# **Missouri River Bed Degradation Feasibility Study Technical Report, Missouri and Kansas**

## **Agency Technical Review**

Review of Draft Technical Report

**Subject:** Review report for review of the Draft Technical Report for the Missouri River Bed Degradation Feasibility Study, March 2017 through June 2017, Kansas City District.

**Figure 1. Stream Bed Changes, Cross section 365.56**

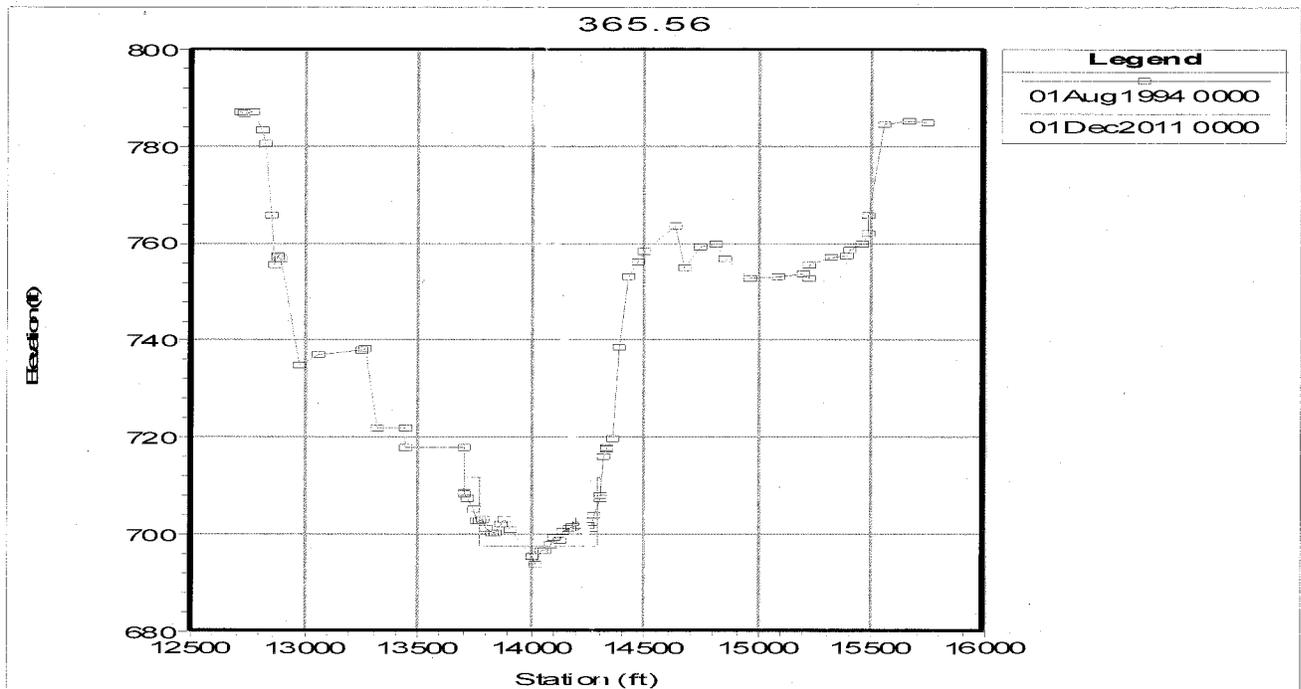
The HEC-RAS model simulates the time period from 1 August 1994 to 30 November 2011, which is the calibration period. The calibration report (pg 33) discusses the bed mixing algorithm and armouring. Armouring (i.e., surface coarsening of the bed materials through selective transport) is generally not observed on sand bed rivers such as the Missouri River, especially sand bed rivers that move bed material sediments mostly as dunes as is observed on the river. We have briefly reviewed some of the results of the HEC-RAS model and question whether the model is properly simulating bed mixing and resulting sediment transport. If the model is not properly simulating sediment transport processes, then the validity of the model and its applicability to simulating bed degradation on the river is not fully established. As an example, we chose XS 365.56 (note that XS also is the River Mile – RM), which lies near the center of the reach near Kansas City where the vast majority of dredging occurred during the calibration time period. The following Figure 1, from the MBM model, shows the cross section at the beginning and the end of the calibration simulation. The difference in cross sectional area and invert elevation is very negligible over the calibration time period, indicating very little net erosion or degradation at this cross section.

**Figure 2. D50 and D90 of surface and subsurface bed material, calibration time period, RM 365.56**

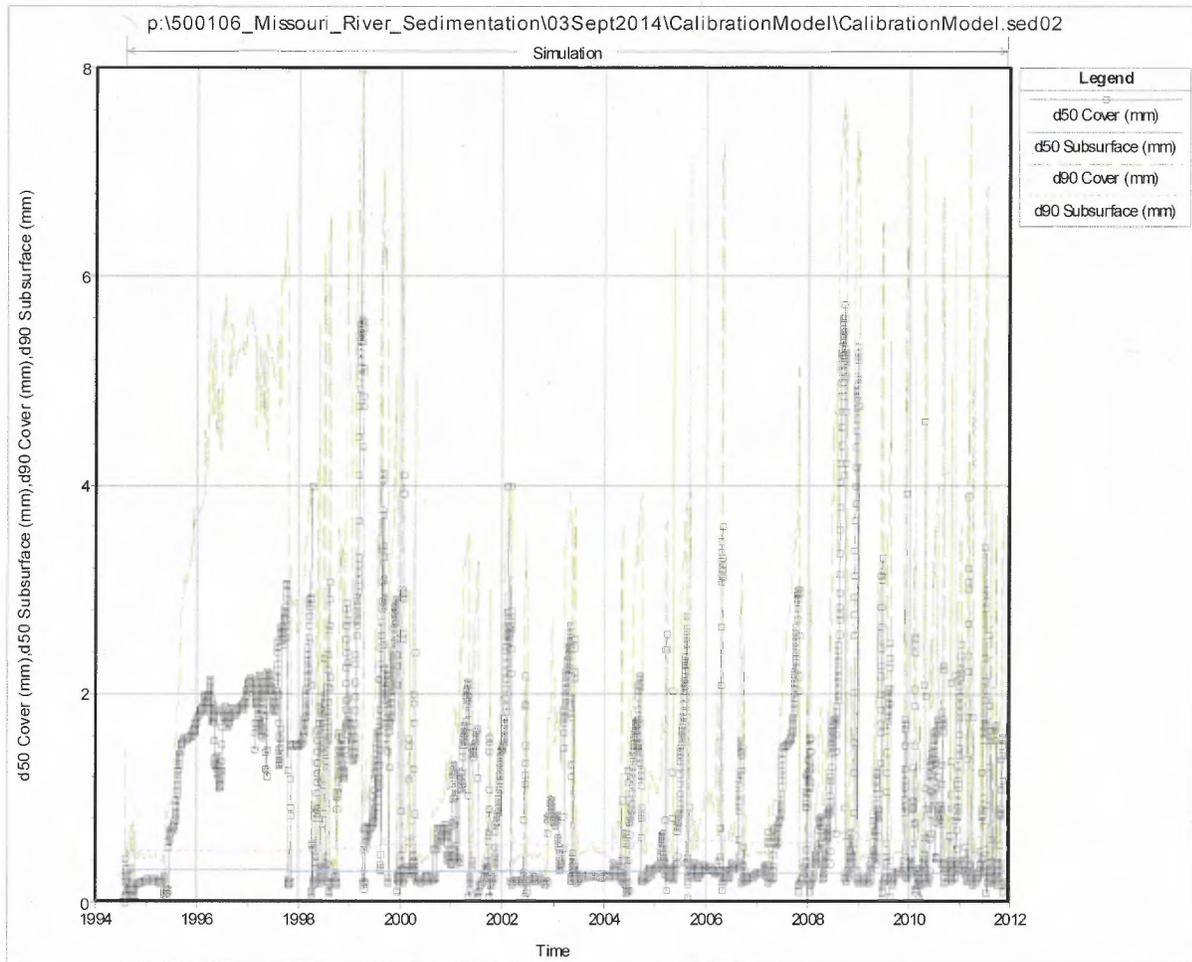
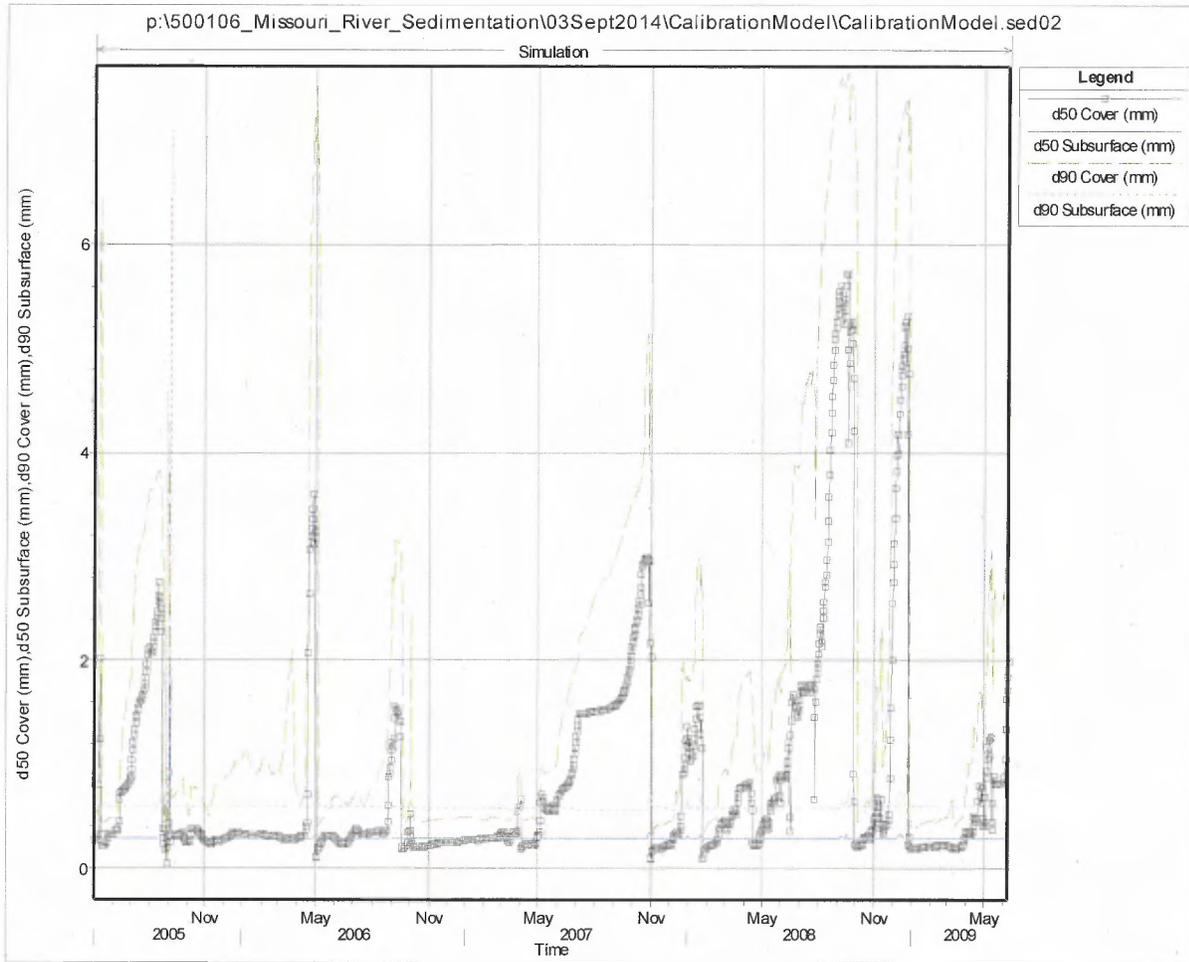
The following two figures show the D90 and D50 (grain size for which 90% and 50% of the bed material is finer) at this cross section. The higher the values of D90 and D50, the coarser the stream bed. Figure 1 shows the D90 and D50 for the surface (bed cover layer) and subsurface materials in the computed bed material at XS 365.56 as it changes over the entire calibration time period. D90 and D50 change in response to the flow conditions. Figure 2 shows the same information but only for a shorter time period chosen at random during the simulation. The figures indicate that the D90 and D50 of the cover layer are greater than 2mm for fairly long durations during the simulation. Note that all references to sediment size and particle descriptions (clay, silt, sand, gravel, etc.) are according to the convention adopted by the American Geophysical Union (AGU). Note that HEC-RAS uses the same convention. Sediment sizes greater than 2mm are gravel sediments and a D50 of 2mm means over 50% of the cover layer is gravel or coarser. It is surprising to see a bed cover layer so coarse (i.e., so much gravel) on a predominately sand bed river. The Calibration Report shows bed material gradations in Table 3 of the report. The gradations shown in Table 3 indicates D90 is less than 2 mm at this location and there was only two locations (RM 330 and 345) where the D50 was greater than 0.5mm (medium sand size). The extent of the surface layer coarsening, as computed by the model, seems unrealistic. The bed gradation, and especially the surface layer, are important parameters in sediment transport predictions.

4.1 The model has been revised, and the final version of the model does not exhibit armoring behavior to the degree cited by Mr. Hall and Mr. Williams. For example, at RM 365.56, the  $d_{50}$  of the cover layer is always in the sand range. It is finer than 2 mm 100% of the time, finer than 1 mm 99.6% of the time, and finer than 0.5 mm 89.1% of the time. This is not excessive armoring for a model of a sand-bed river.

**Figure 4. Computed mass bed change and specified dredging volumes, entire study reach**

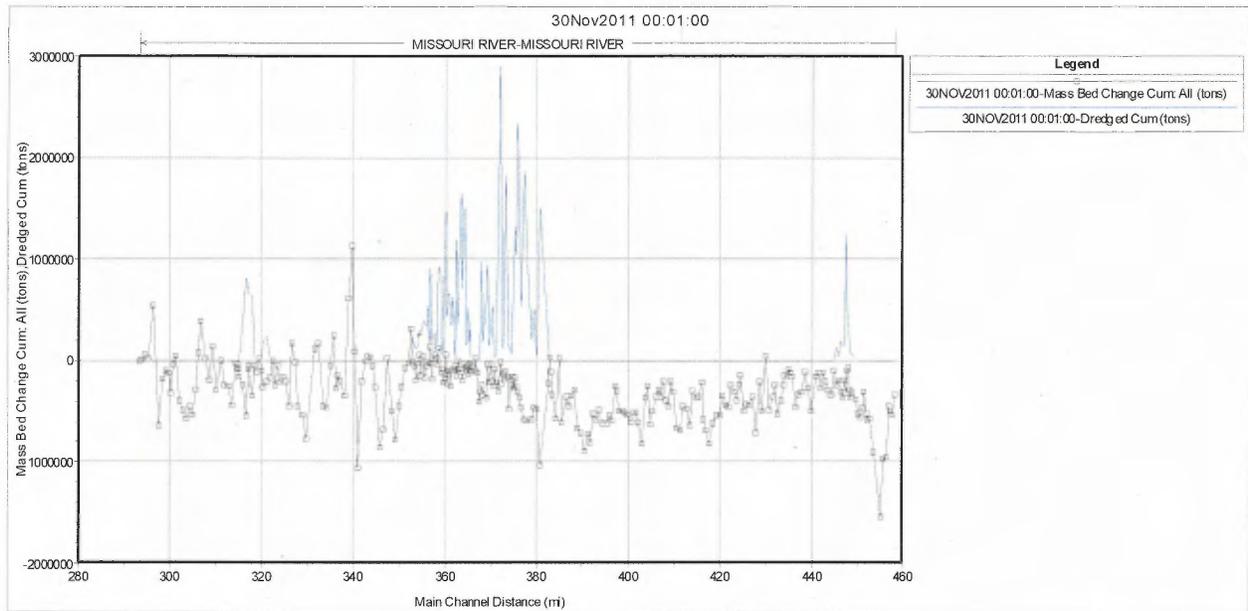
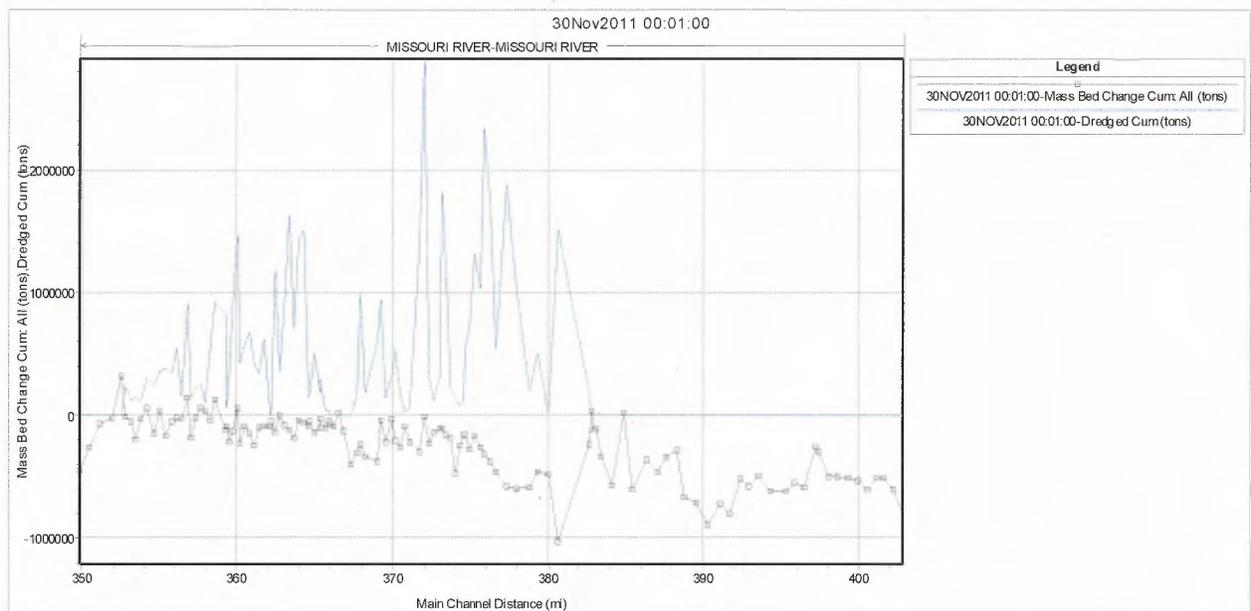
HEC-RAS computes changes in the cross sectional elevation (also referred to as bed elevation change) by a mass balance of the inflowing sediment load minus the outflowing sediment load. The outflowing sediment load is a function of the transport capacity immediately upstream of the load location, the bed material size, and the availability of bed material for transport at the near cross section locations. The cumulative mass bed change at each cross section for the calibration time period is shown on the following Figure 4. The cumulative mass of dredge material is also shown on the same figure. The first observation is that a significant portion of the cumulative bed change occurs upstream of the dredging reach (~RM 350-380). Since the bed change is directly computed from what is coming in minus what goes out (the out includes dredging), then the computed bed changes upstream of RM 380 cannot be due to dredging. The second observation is that the computed bed change at the downstream portion of the dredge reach (RM

350 to 370) shown in Figure 5 indicates very little change in bed degradation over this reach where dredging occurred over the calibration time period.

**Figure 6. Computed invert elevation change**

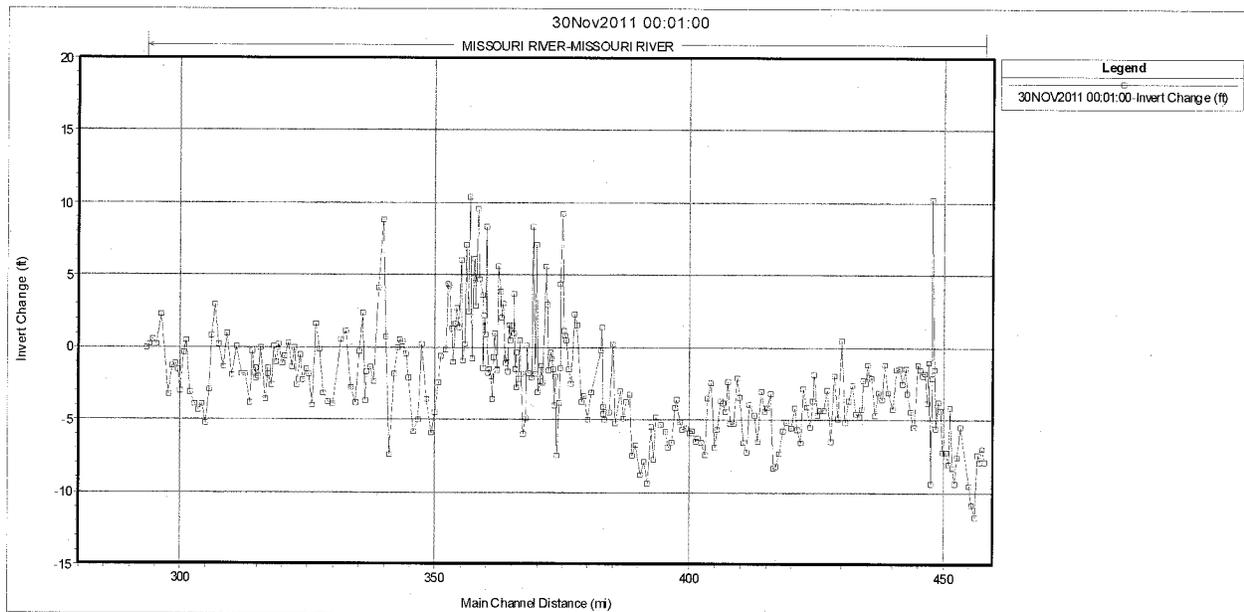
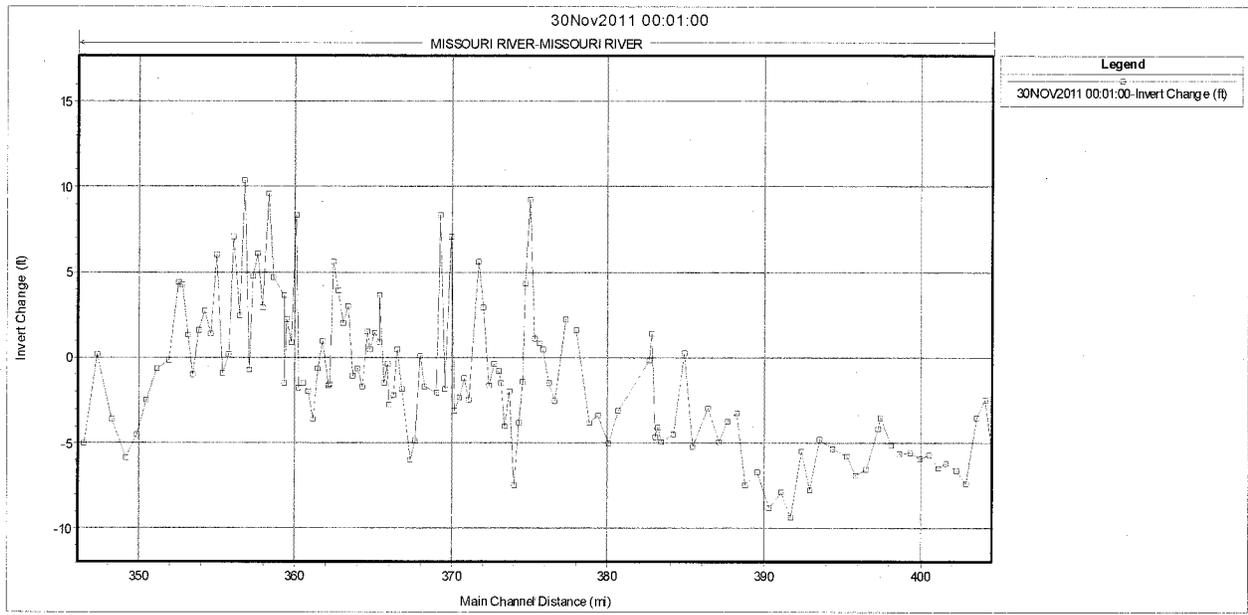
Another way to look at bed change in a mobile bed model such as HEC-RAS is to look at the change in invert elevation. The net channel area is most important for assessing changes in sediment storage throughout a reach. However, the changes in invert elevation, especially in a 1-dimensional model such as HEC-RAS, are indicative of net sediment erosion or deposition within a reach. The change in invert elevation for the calibration time period is shown on the following Figure 6. The invert elevation generally shows a decrease (i.e., erosion) upstream of the dredging reach, RM 350 – 380. The invert elevations through the dredging reach show fairly wide variability of both erosion and deposition which indicates that the dredging simulation in HEC-RAS does not seem to directly lead to excessive erosion in the dredging reach. In fact, there is more erosion upstream of the dredging reach than in the dredging reach and downstream areas. If there was a significant erosion effect of dredging, it would manifest itself downstream of the dredging reach. This computed reduction in invert elevation upstream of the dredging reach and lesser change of invert within the dredging reach (see Figure 7) is consistent with the cumulative mass changes shown in Figures 4 and 5 above. It had been argued that the erosion upstream of the dredging reach could be caused by a headcut or knickpoint migration but the dredging methods and lateral extent of the dredging operations is not conducive to the phenomena of headcutting.

**Figure 8. Computed bed material mass changes by grain size**

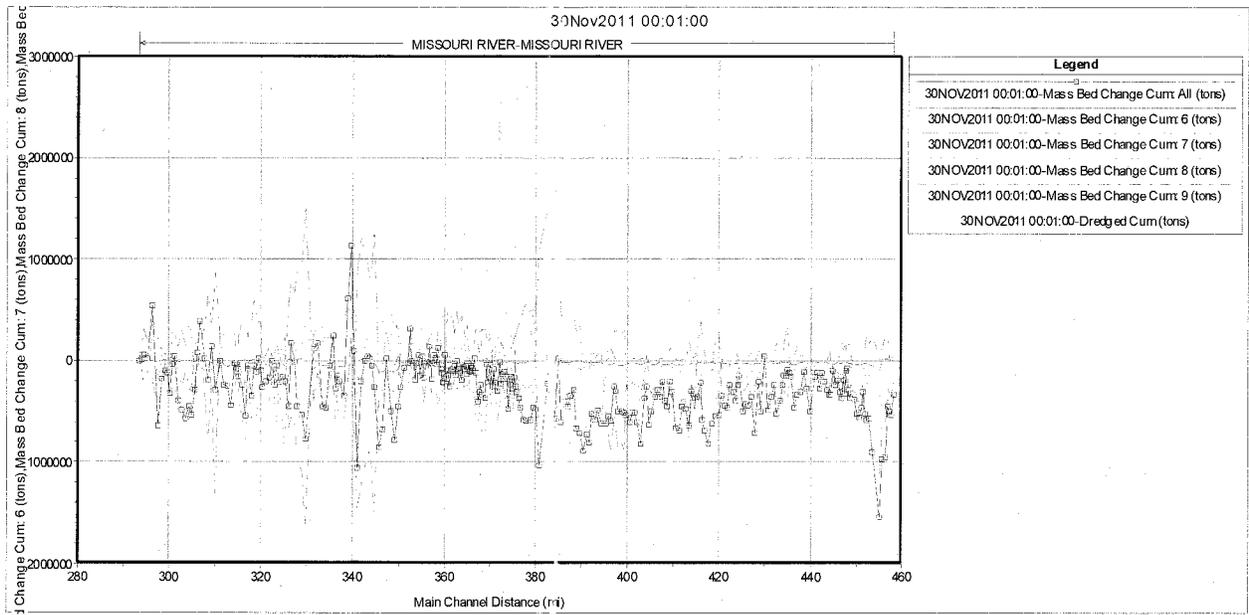
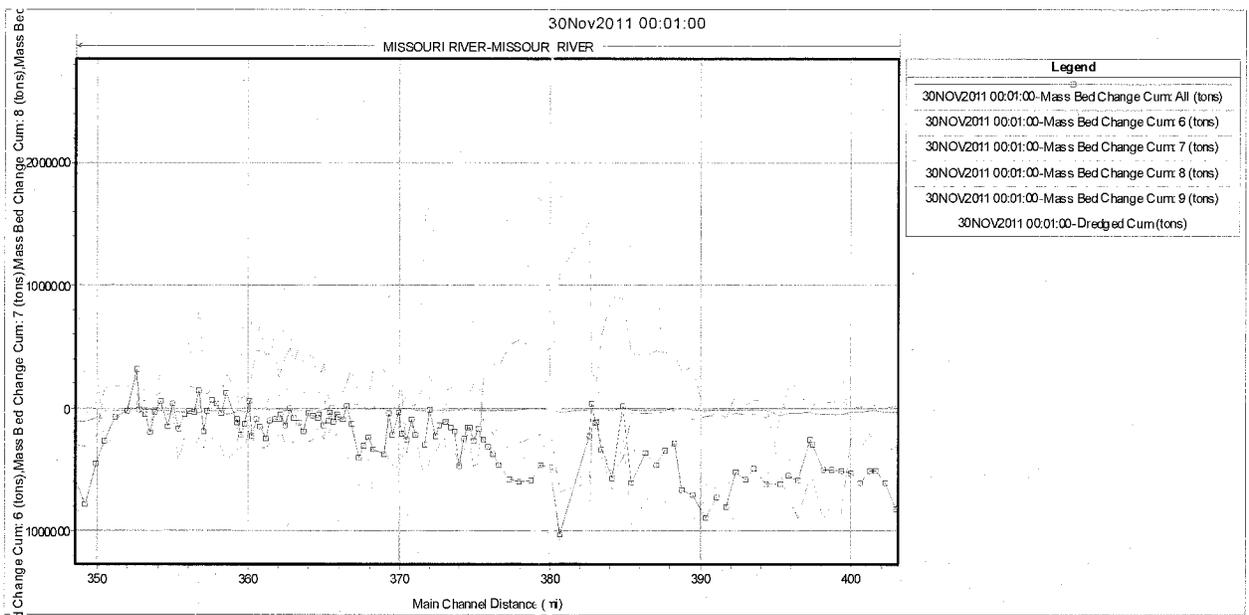
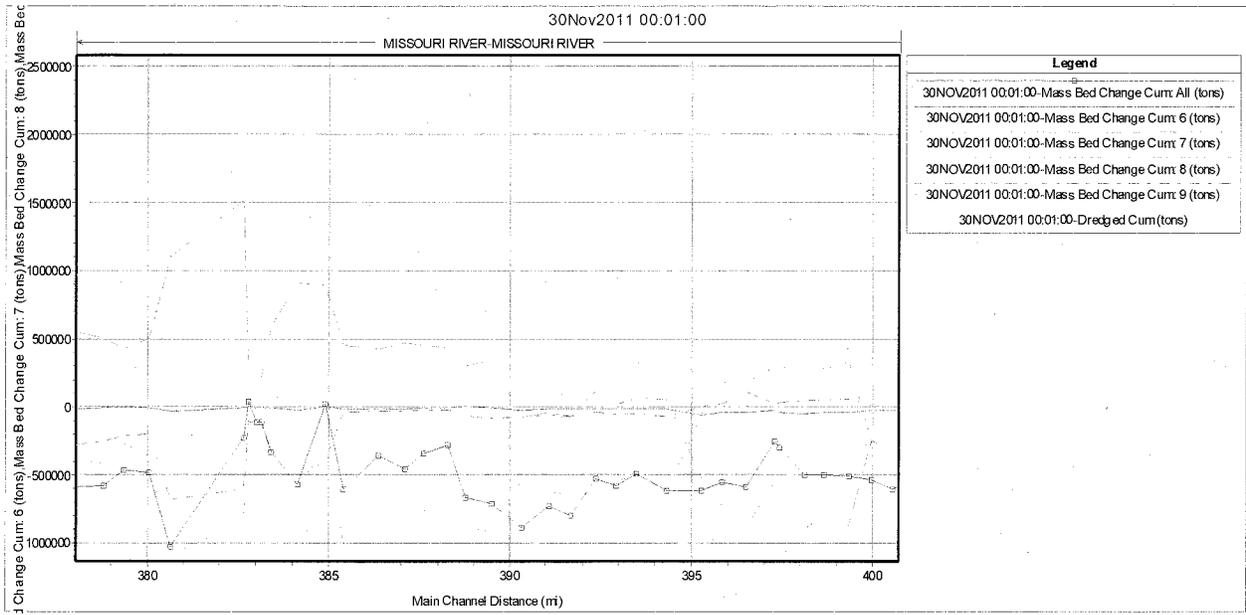
An additional observation in this initial model review is an inconsistency in computed sediment flux by grain size through the MBM model. Sediment transport theory indicates that the relative mobility of sediment decreases with increasing grain size. Looking at the net bed change by mass for each grain size, patterns of selective transport of coarser sediment over finer sediment is observed, which is contrary to sediment transport theory. In the following Figures 8 through 10, the accumulated mass change of sediment by grain size at each cross is plotted. Grain size 6 corresponds to very fine sand (<.125 mm), size 7 is fine sand (<.25 mm), size 8 is medium sand (<.5 mm) and size 9 is large sand (<1 mm). The net mass bed change for all size sediments is also plotted as the solid black line. The solid blue line on the figures indicate that there is very little net bed change due to erosion of very fine sand throughout the reach. This is consistent with the measurements that little very fine sand is found in the bed of the Missouri River in this reach. An inconsistency shows up in the computed zones of net erosion or deposition of fine sand (the green dashed line) vs. erosion or deposition of both medium sand and coarse sand (the pink and red dashed lines, respectively). There are locations (i.e., RM 375 – 390) where the HEC-RAS model computes net deposition of fine sand while net erosion of medium and coarse sand occurs in the same reach. This is inconsistent with both the relative mobility of these different size sediments as well as the plausible effects of any selective transport mechanisms.

4.4 The model has since been revised, and the final version of the model does not exhibit this behavior to the degree cited by Mr. Williams and Mr. Hall. That said, grain sizes are variable in time and over space, depending on (1) the proportion of that grain size in the bed, (2) the ability of the water to move sediment, (3) the grain size of the sediment input from upstream or from tributaries, and (4) armoring effects (which tend to be temporary and cyclical). Due to all the above factors, plus commercial dredging, variation at individual cross sections is expected. Notwithstanding, the mobile-bed model replicates the overall geomorphic behavior and is adequate for modeling sediment in this study.
